RE: Proposed Industrial/Warehouse Building
35 Saratoga Boulevard, Devens, MA

Bayside Engineering is in receipt of Nitsch Engineering's (Nitsch) Peer Review letter dated August 26, 2022 review of the Sight Distance materials prepared for the proposed warehouse to be located at 35 Saratoga Boulevard in Devens, MA. The purpose of this letter is to respond to the comments raised on the Bayside materials. The Nitsch comments requiring additional response are addressed below.

Figure 1S

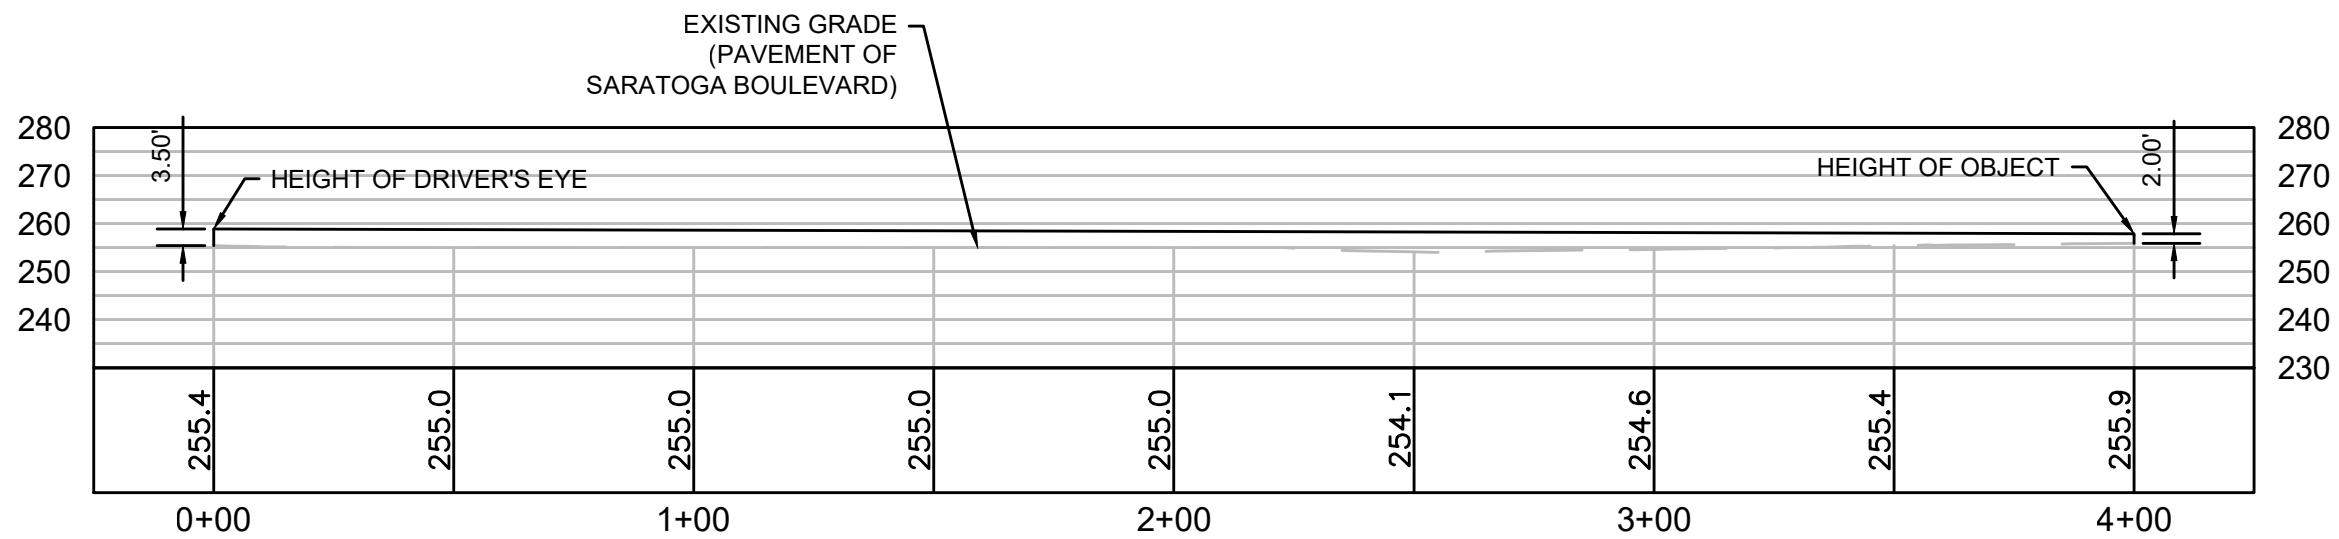
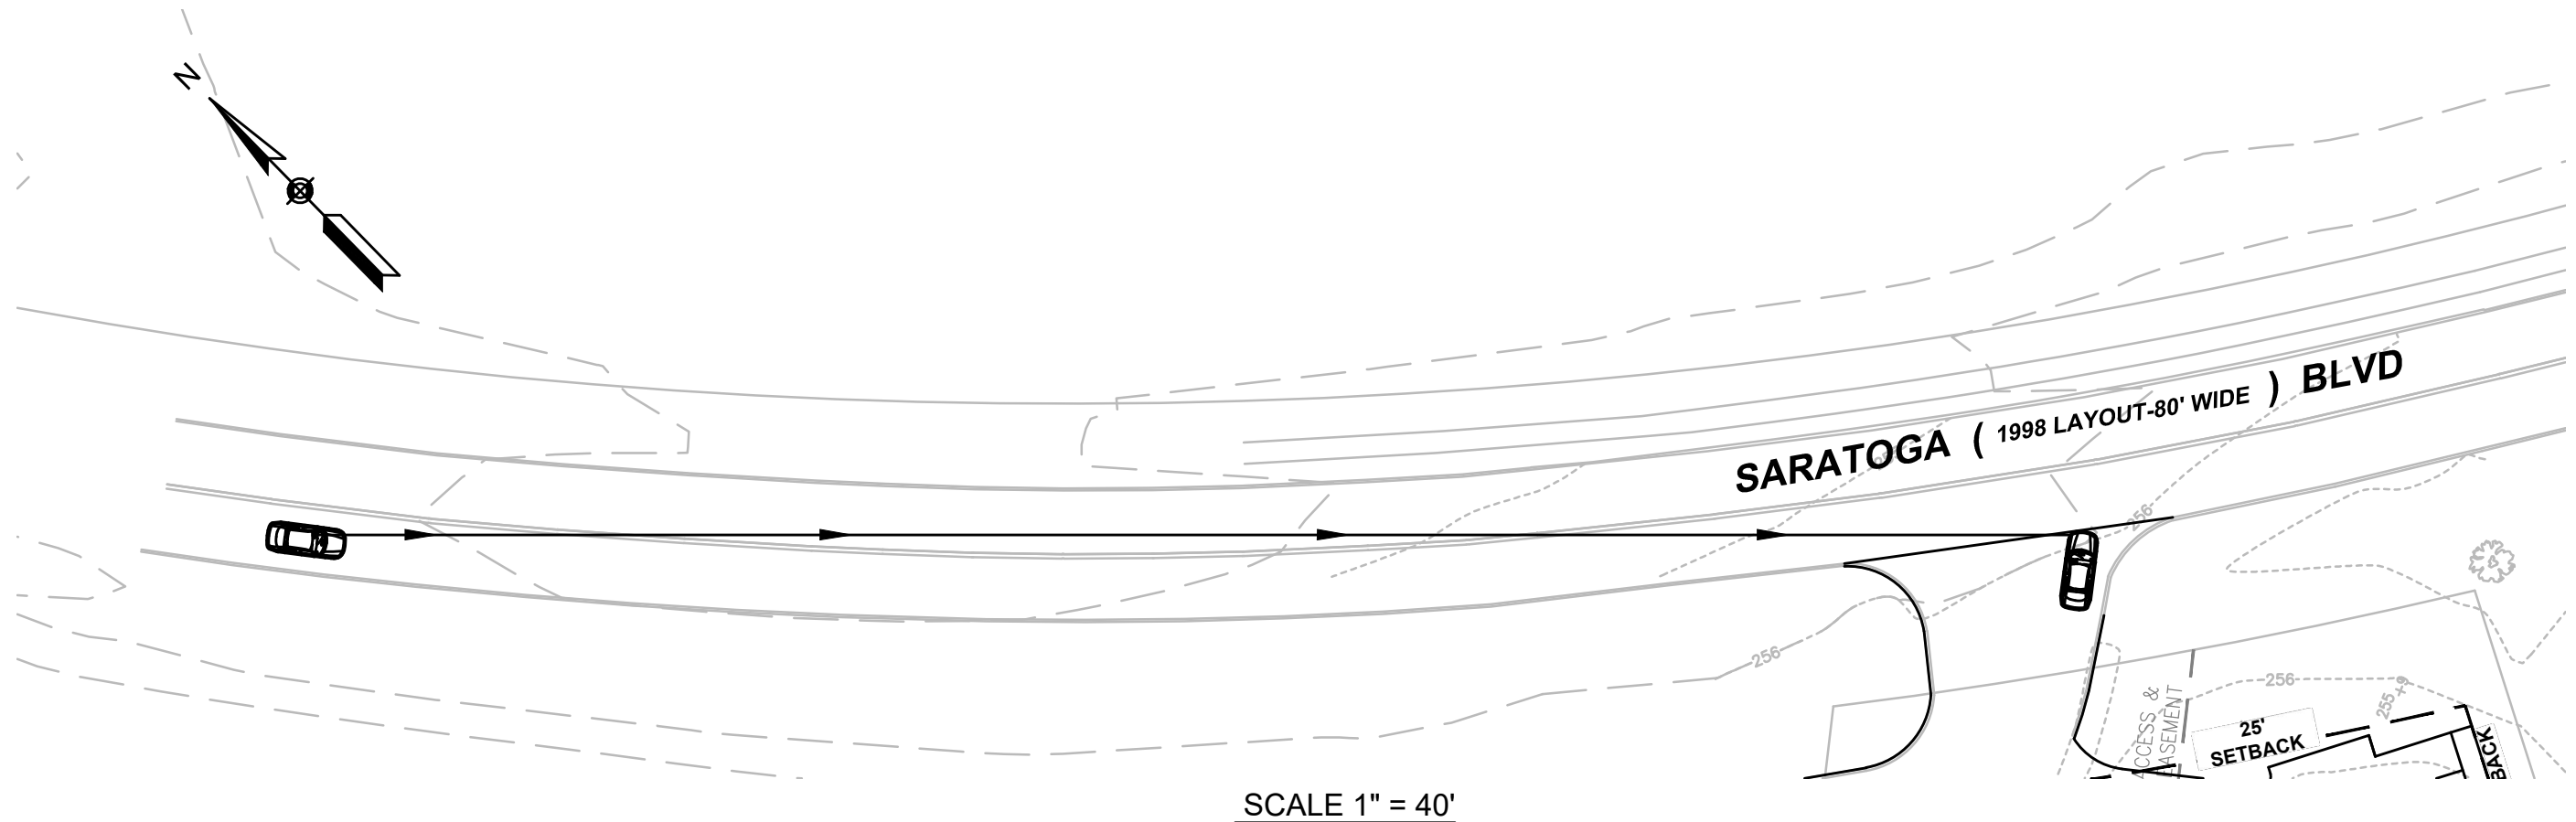
At the meeting with the DEC on August 29, 2022, it was requested that sight distance graphics be provided for the site driveway to Saratoga Boulevard. Figures 1S through 4S in the Appendix show the stopping sight distances and intersection sight distances at this driveway.

Figure 1B
Stopping Sight Distance
Approaching from East
Barnum Road Driveway

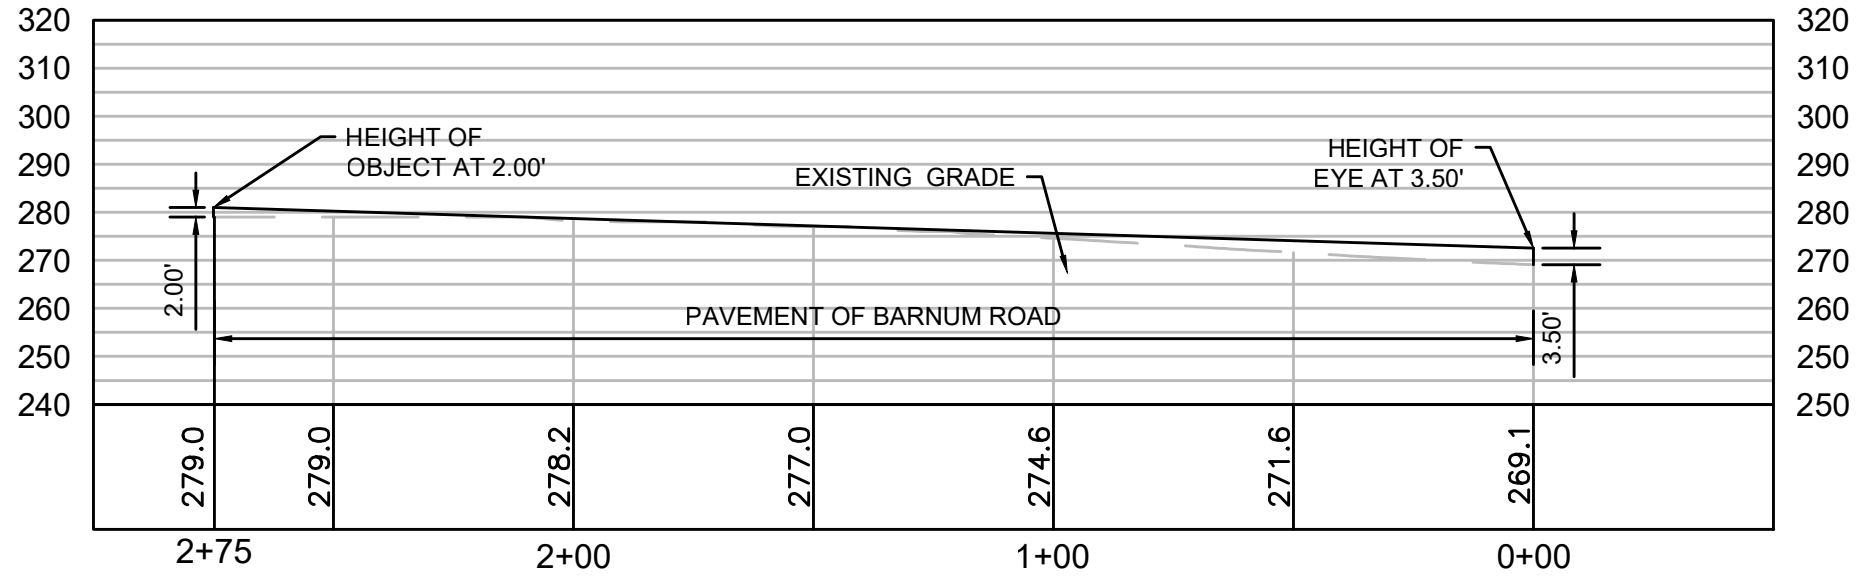
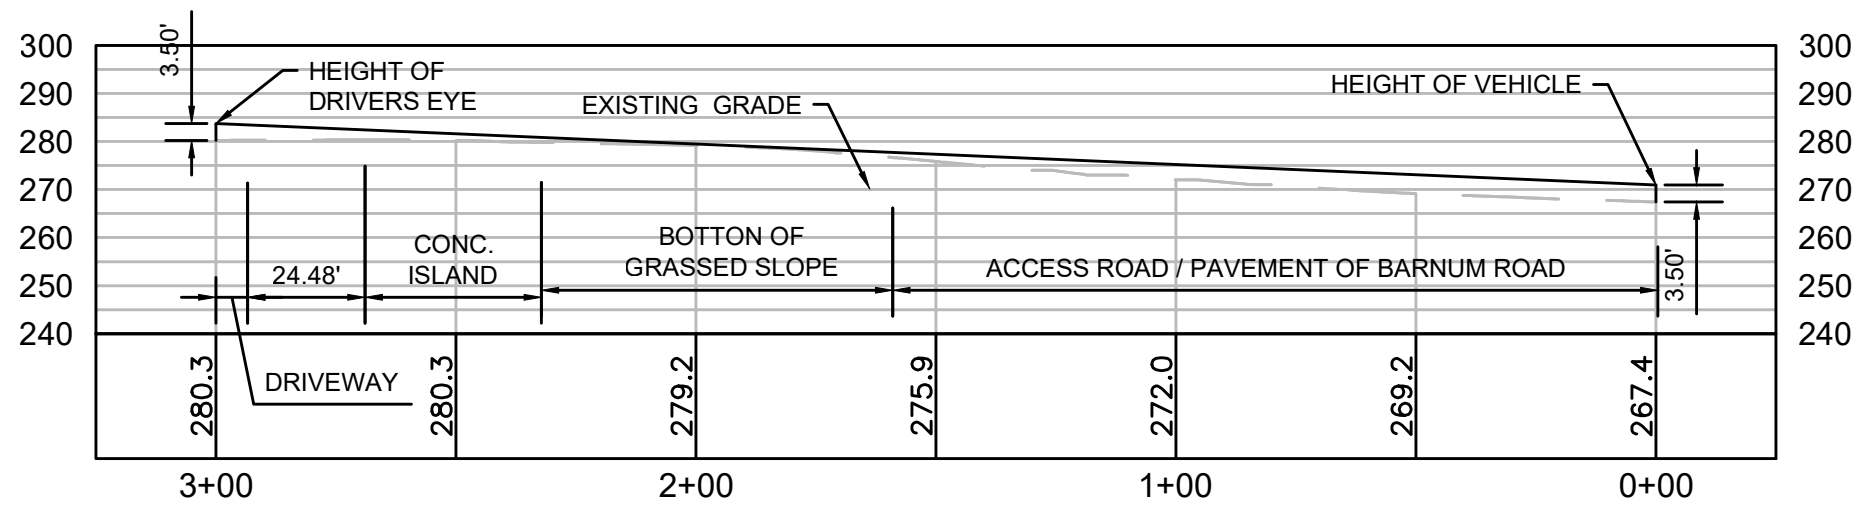
Nitsch Response (08/25/2022): No new Figures 3 and 4 were provided, so we assume this is referring to the Figures 3 and 4 included in the applicant response from May 31, 2022. However, Figures 1 and 2 were updated in the interim and still have questions that are outstanding – see Comment 30. There have been inconsistencies between figures and changes that could affect sight distance measurements. Please provide updated Figures 1-4 with all relevant comments incorporated, and please label the visual obstruction along the sight line, be it a roadside slope, the roadway itself within the vertical curve, or otherwise. In other words, show how the sight line vector was constructed such that it was then measured in CAD. As shown currently, it looks like the vehicle on the roadway is placed at an arbitrary distance from the driveway and a line is drawn between the two vehicles. Show how that line was made. If the visual obstruction is the roadway itself, is that the purpose of the profile view, and if so, is the existing grade for the roadway centerline or does it follow the sight lines? This distinction is particularly important for the sight lines that cross over the roadside.

Applicant Response: *The original sight distance graphics are no longer valid as the Barnum Road driveway location has changed slightly and the driveway now will permit right turns in/out only. As such, the only sight lines that come into play are approaching from the east for the SSD and looking to the east for the ISD. Updated sight line graphics, Figure 1B and 2B, are included in the Appendix.*

For the SSD graphics, the height of driver's eye recommended by AASHTO is 3.5 feet above grade. The height of object at the edge of travelled way is 2.0 feet. Using the proposed driveway as the point of reference, a vehicle was placed in the exiting lane with its bumper on the edge of travelled way. From this point, starting at a height of 2.0 feet above grade, a line was drawn to the east just over the topographical features along the property frontage and Barnum Road driveway, just above the associated grade until the line was 3.5 feet above grade, representing the driver's eye height. All grades, existing and proposed, for the sight distance graphics were obtained from site planes prepared by Eugene T. Sullivan, Inc.
